Access Compliance Report

Public Rights-of-Way

(Curb Ramps)

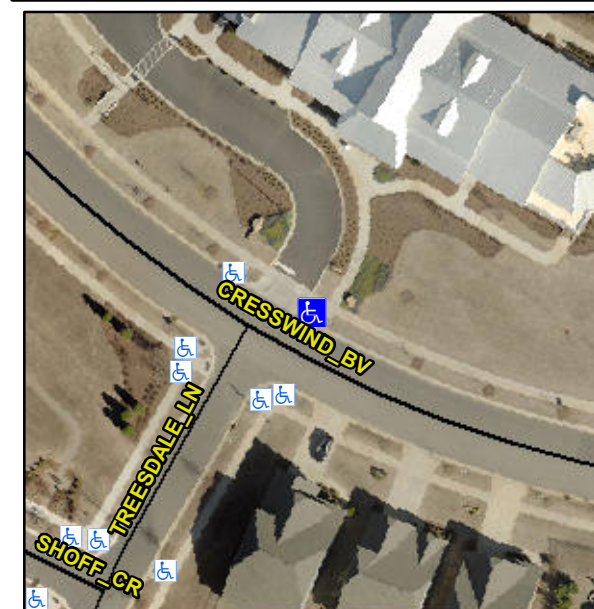
Not Found, R304.5.3

Compliance	Description	Data	Compliance	Description	Data
N/A	Ramp Length (in)	96.6	Yes	Ramp Slope (%)	5.4
Yes	Ramp Width (in)	59.0	No	Ramp XSlope (%)	2.6
N/A	Flare Type LT	N/A	N/A	Flare Type RT	N/A
N/A	Flare Slope LT (%)	N/A	N/A	Flare Slope RT (%)	N/A
N/A	Flare Traversable LT?	No	N/A	Flare Traversable RT?	No
N/A	Landing Length (in)	N/A	N/A	DWS Provided?	N/A
N/A	Landing Width (in)	N/A	N/A	DWS Contrast?	N/A
N/A	Landing Slope (%)	N/A	N/A	DWS Length (in)	N/A
N/A	Landing X Slope (%)	N/A	N/A	DWS Full Width?	N/A
N/A	Landing Curb? (Y/N)	N/A	N/A	DWS Offset (in)	N/A
N/A	Shared Landing?	N/A			
N/A	Gutter Ponding?	N/A	N/A	Gutter Slope (%)	N/A
N/A	Gutter Lip Ht (in)	N/A	N/A	Gutter X Slope (%)	N/A
N/A	Painted X Walk1?	No	N/A	Painted X Walk2?	N/A
	X Walk 1 Direction	To SW		X Walk 2 Direction	N/A
N/A	X Walk 1 Width (in)	N/A	N/A	X Walk 2 Width (in)	N/A
	X Walk 1 Slope (%)	2.6		X Walk 2 Slope (%)	N/A
	X Walk 1 X Slope (%)	0.7		X Walk 2 X Slope (%)	N/A

Remove & Replace Entire Ramp.
